Proposal for the 01 series of amendments to UN Regulation No. 35 (ECE/TRANS/WP.29/GRSG/2019/3 on Foot controls)

The text reproduced below was prepared by the expert from the International Organization of Motor Vehicle Manufacturers (OICA) to clarify the measurement method of the lateral distance of the pedals to the nearest "wall" to the left. It is based on informal document GRSG-115-17, presented at the 115th session of the Working Party on General Safety Provisions (GRSG) (see report ECE/TRANS/WP.29/GRSG/94, para. 14). The modifications to the current text of UN Regulation No. 35 are marked in bold characters.

Annex 1, item 5, amend to read:

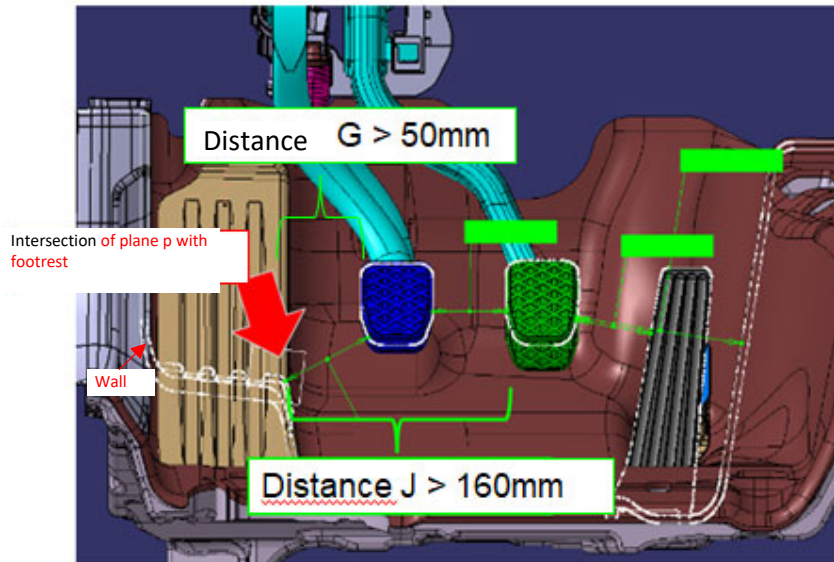
"5. Brief description of the vehicle type as regards the arrangement of foot controls **and foot rest**"

Current Regulation: Three pedals – Conventional transmission

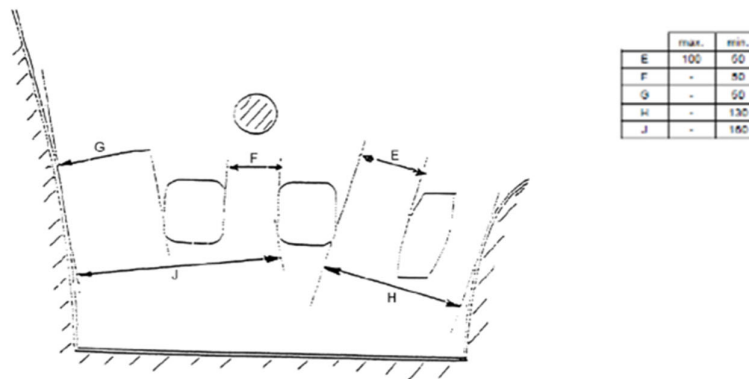
2. This proposal hence clarifies the measurement method for the lateral distances of the pedals to the nearest "wall" to the left. For safety and comfort reasons foot rests are installed for the drivers' left foot. The rest plane of such foot rests can intersect the measurement plane "P". This proposal clarifies that, in such cases, the required clearance for the left foot is measured on top of the foot rest, rather than between the left most pedal and the foot rest itself.

Example of possible interpretation when footrest exists under current regulation text:

Current Regulation Text: Two pedals – Automatic transmission

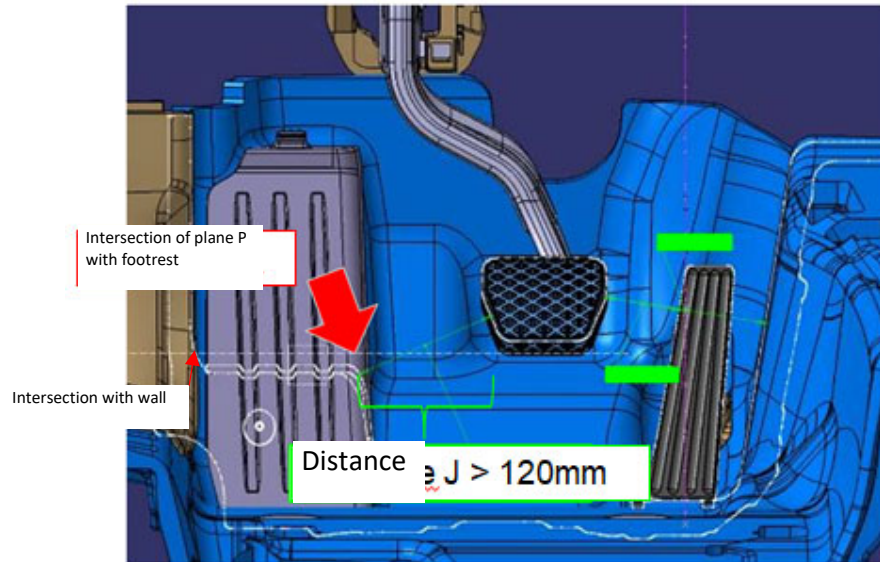
Example of possible interpretation when footrest exists under current regulation text:
